7.5 Block B - Residential Entrance

7.6 Block B - Appearance

7.7 Block C - Layout

Site B Basement

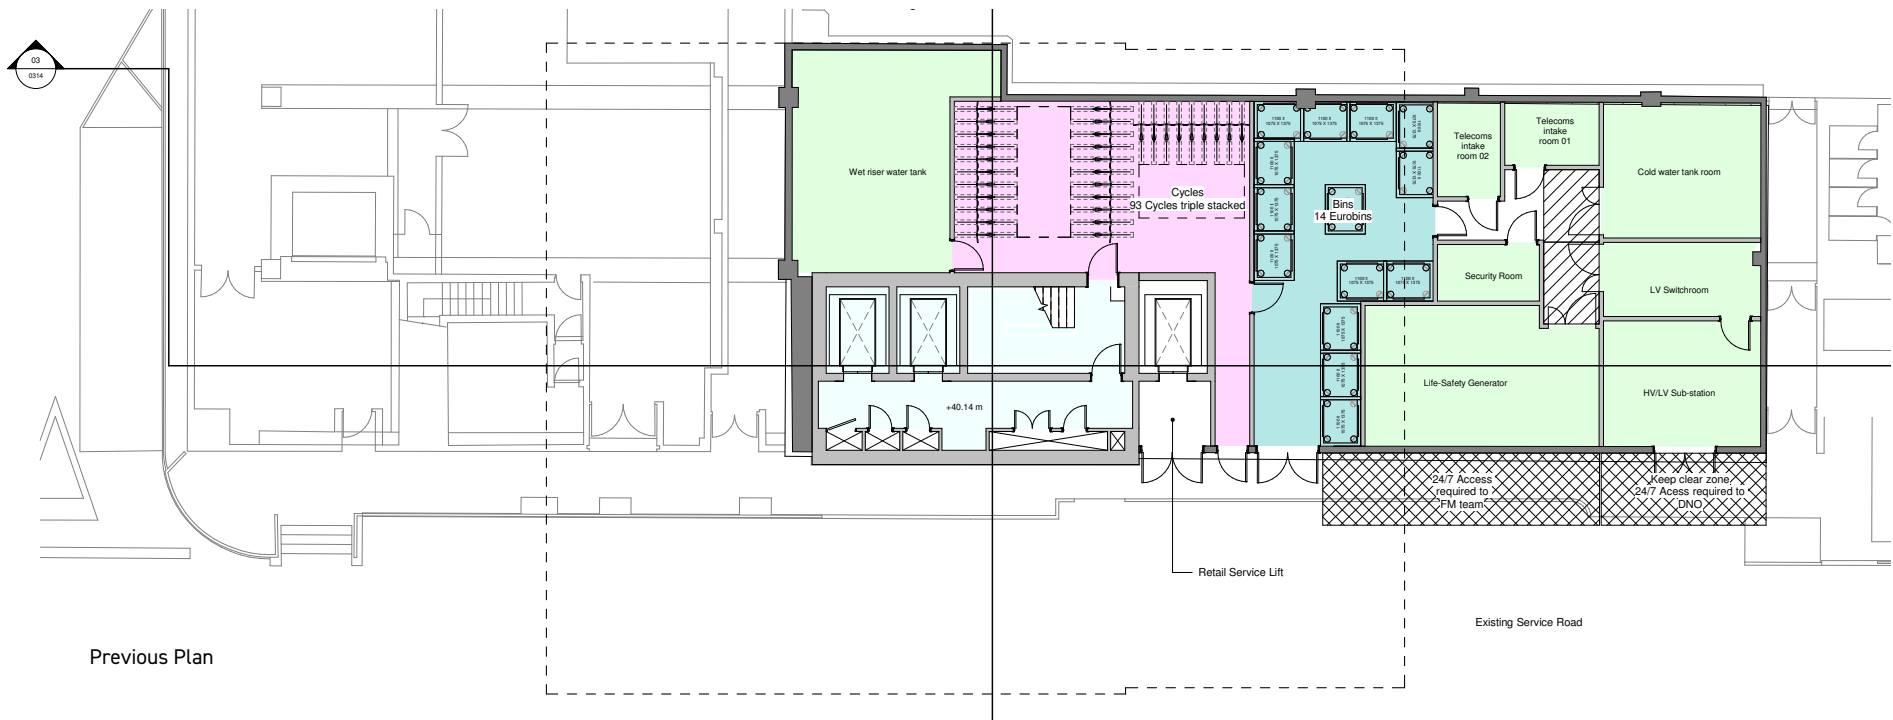
- Double stacked cycle storage (Josta two-tier)
- Access door from refuse store now inset to not interfere with highways
- changes to M&E requirements
- Servicing of 2 retail units above at this level

Site C Basement

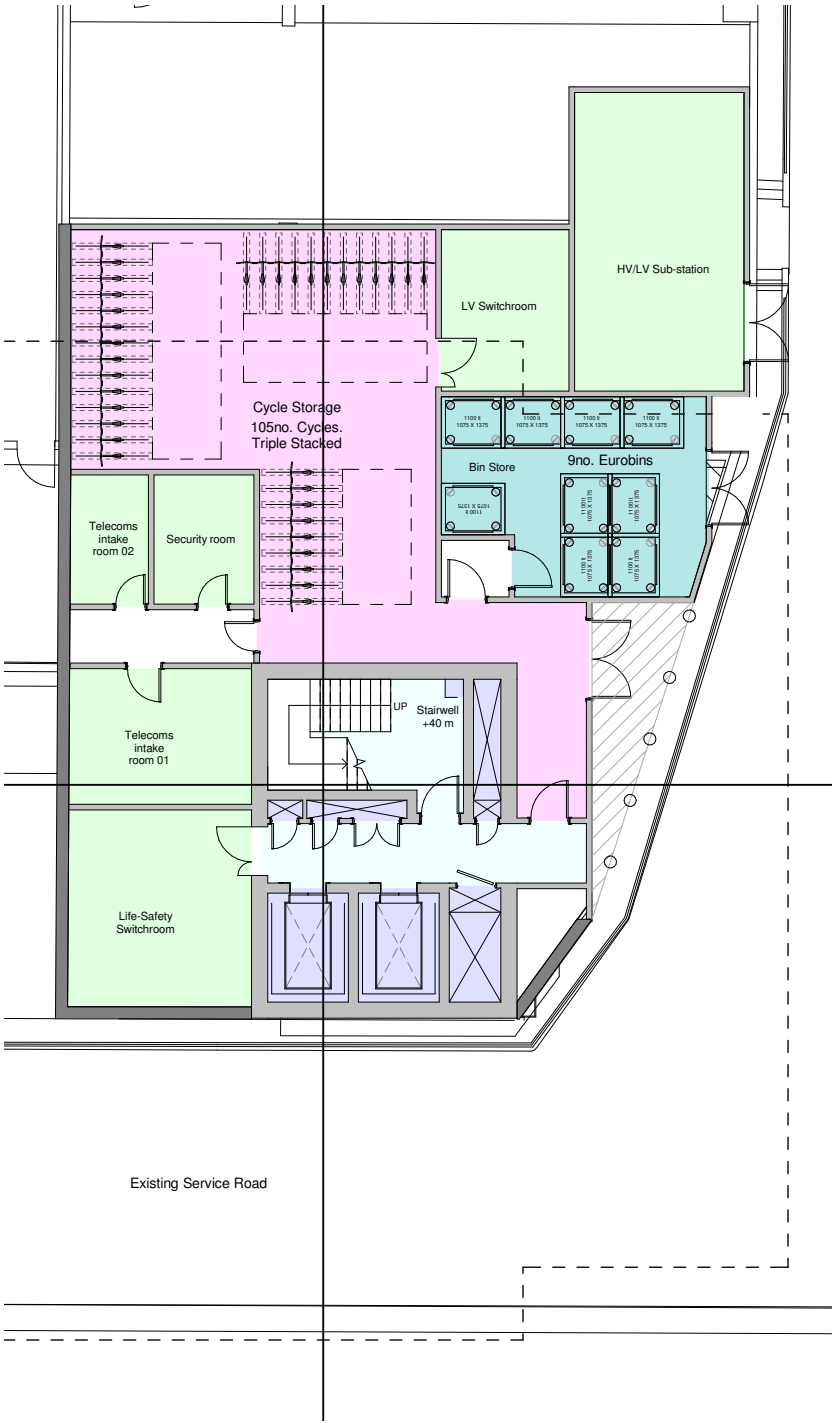
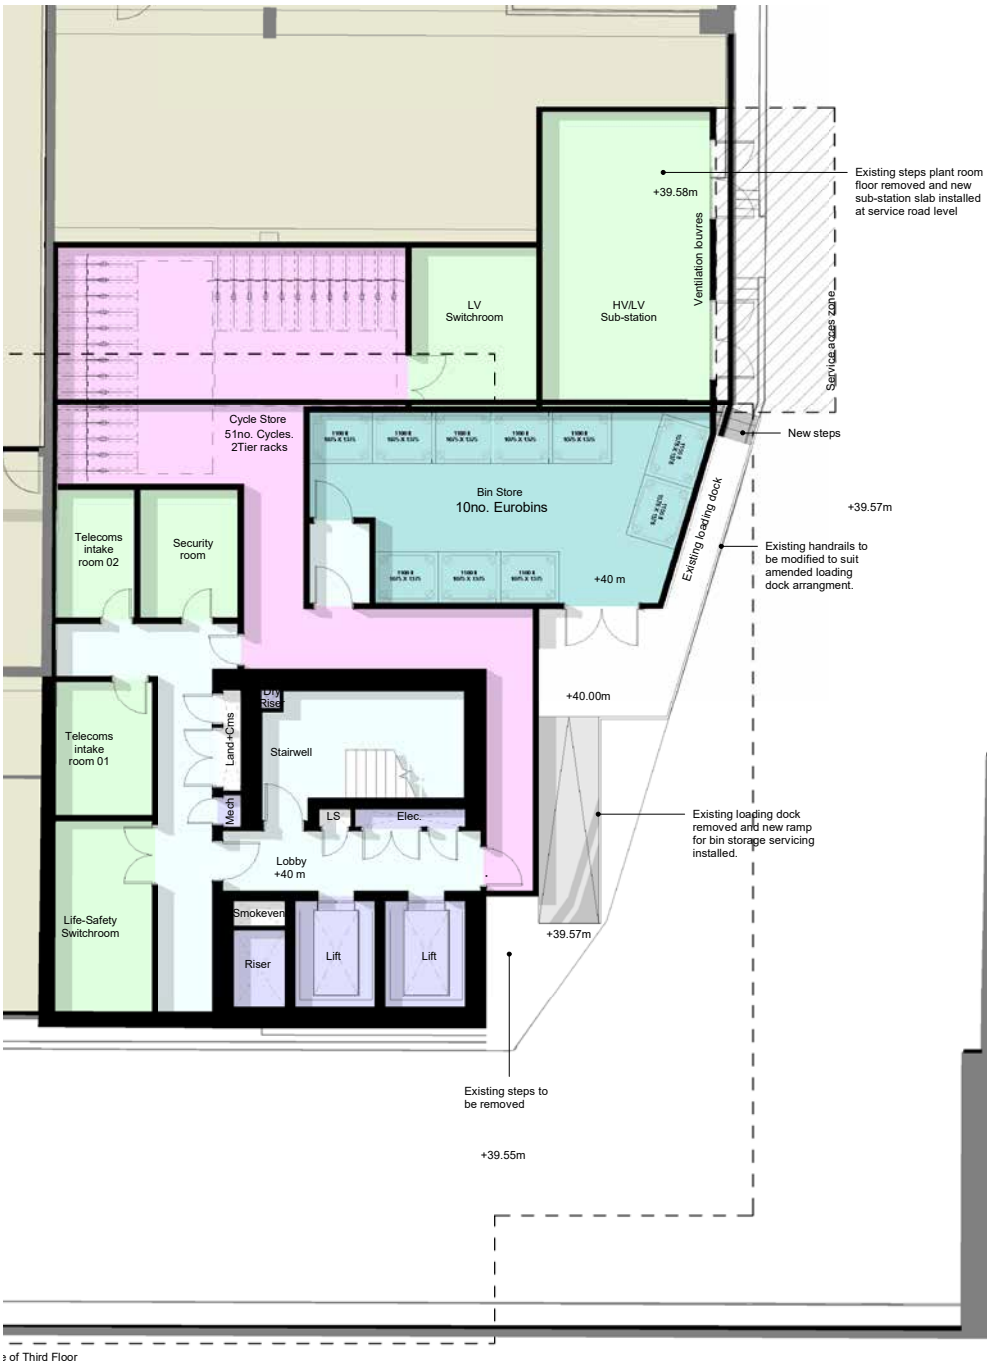
- Double stacked cycle storage (Josta two-tier)
- Highways comments incorporated
